**PREVOST**

## SAFETY RECALL

Sr12-29

<b>DATE :</b> SEPTEMBER 2012	<b>SECTION :</b> 23-ACCESSORIES
<b>SUBJECT :</b> AUTOMATIC FIRE DETECTION AND SUPPRESSION SYSTEM (AFSS) – PROTECTION OF LINEAR THERMAL DETECTOR (LTD)

IR OPTICAL  
FIRE DETECTOR  
LOCATION

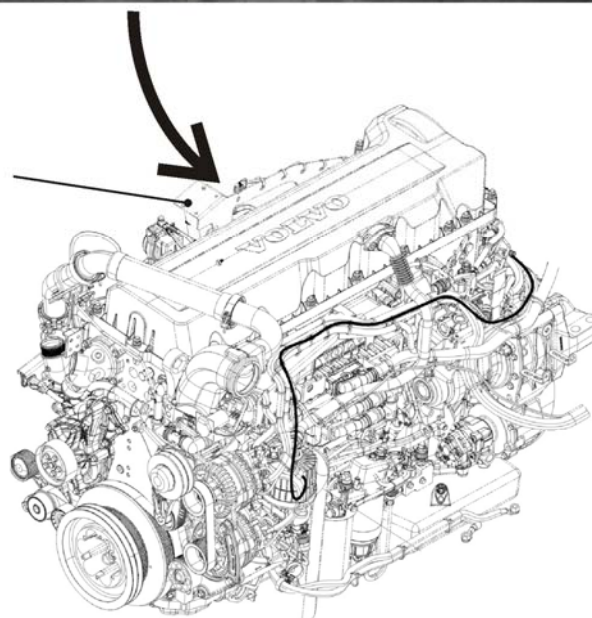
PROTECT LINEAR THERMAL DETECTOR SHEATH FROM RUBBING AT THIS LOCATION. CUT NYLON TIE AND ADD INSULATING FABRIC ADHESIVE TAPE. FIX WIRE WITH A NEW NYLON TIE.

1. There is only one location where the protective fabric tape might be too short or improperly located. Check the engine turbocompressor side near the optical infrared (IR) fire detector (see image above).

2. Cut and remove the existing nylon tie. Add enough fabric tape to protect LTD (red cable) from rubbing against the nylon tie. Fix LTD cable at the same location using included nylon tie.
